**CITY OF BATON ROUGE
PARISH OF EAST BATON ROUGE
DEPARTMENT OF PUBLIC WORKS
SEWER ENGINEERING DIVISION**

ADDENDUM NO. 4

SUBJECT: FLORIDA BOULEVARD PUMP STATION IMPROVEMENTS
CITY-PARISH PROJECT NO. 11-PS-MS-0003

STANDARD PLAN NO. 805-04	DATED AUGUST 1, 2011	SHEET NO. 1 OF 2
-----------------------------	-------------------------	---------------------

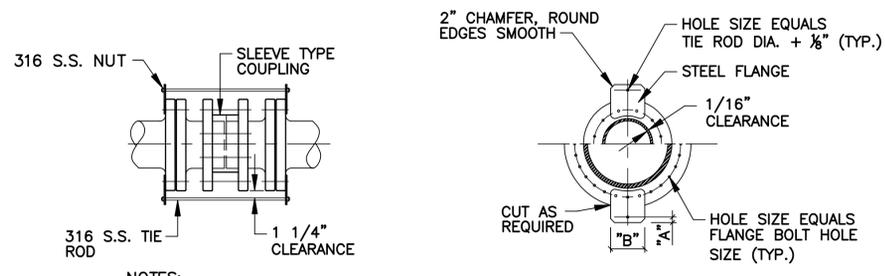
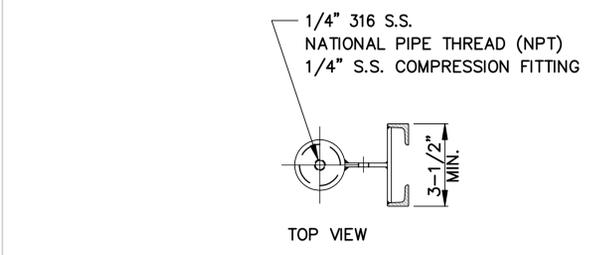
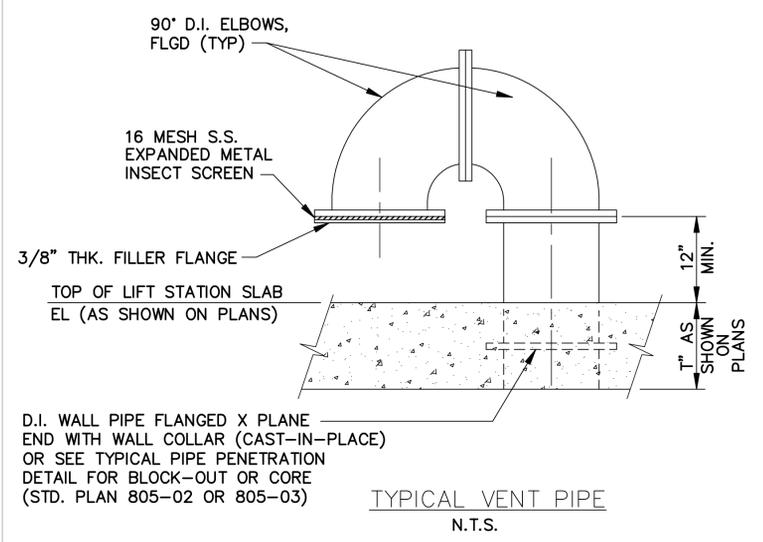
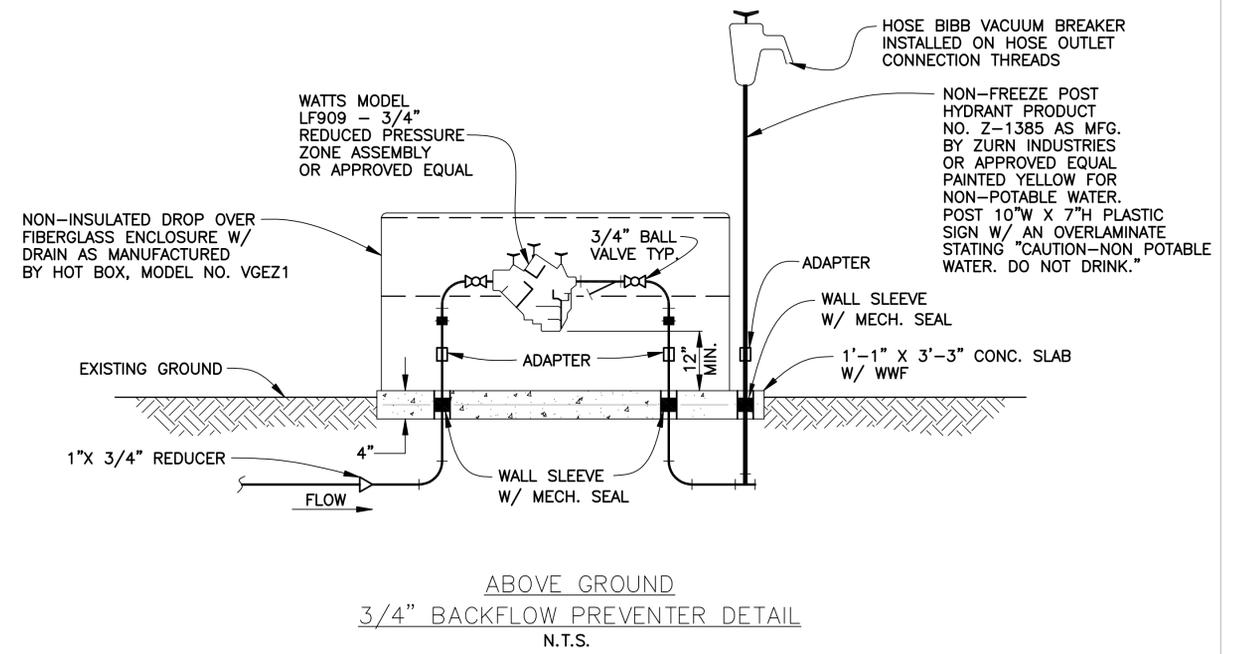
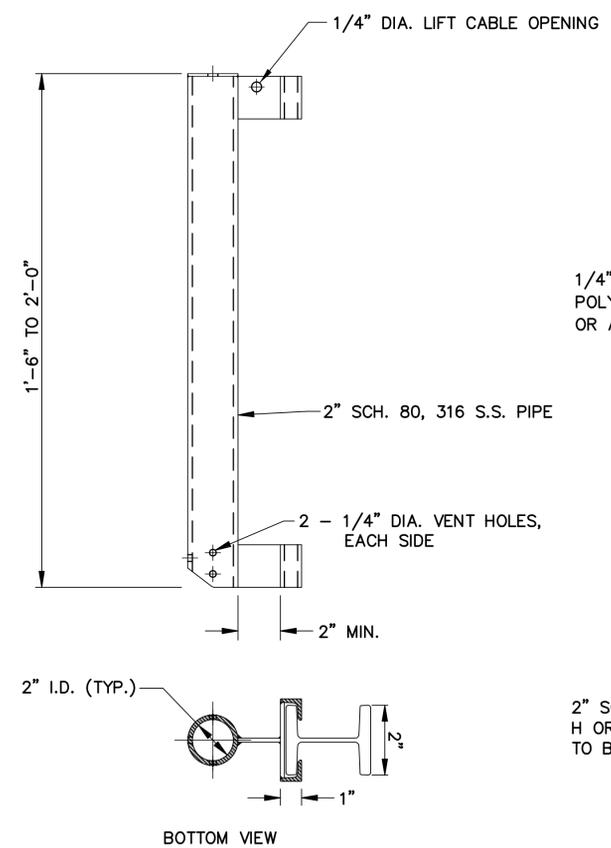
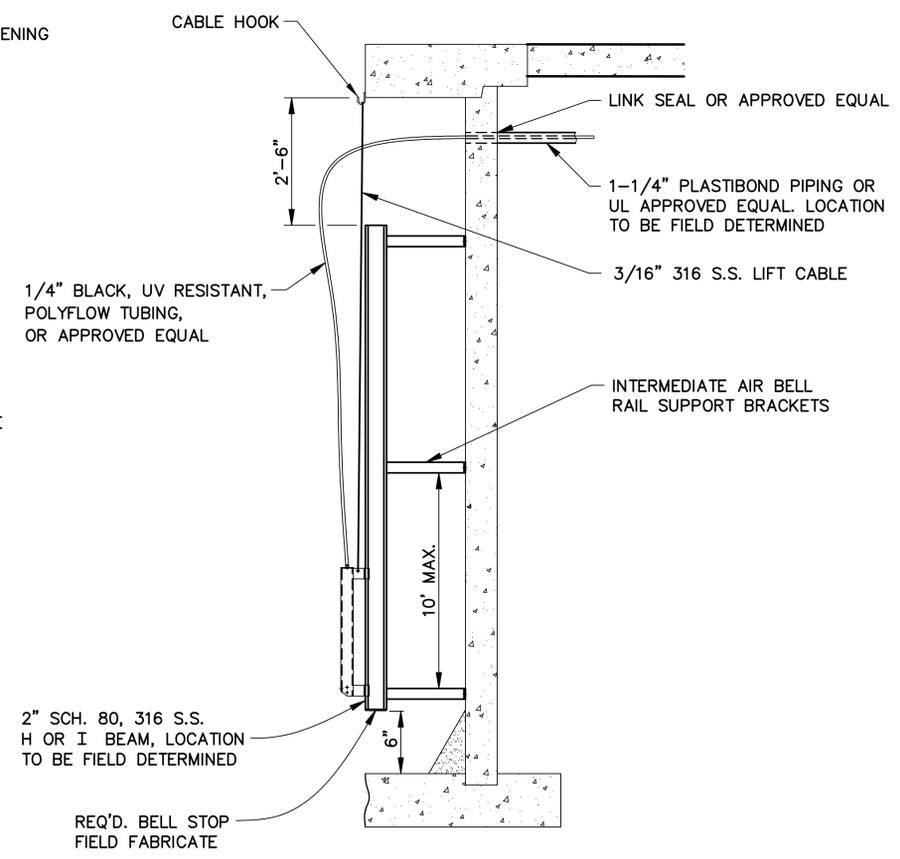
12. Delete EBR Parish Standard Plan No. 805-04 (1 of 2) and (2 of 2) and Replace with attached Revised EBR Parish Standard Plan No. 805-04 (1 of 2) and (2 of 2).

8/16	REVISED VENT PIPE DETAIL & ADDED FLEX COUPLING DETAIL	A.M.S.
4/13	REVISED TITLE BLOCK	A.S.
DATE	DESCRIPTION	BY
	REVISIONS
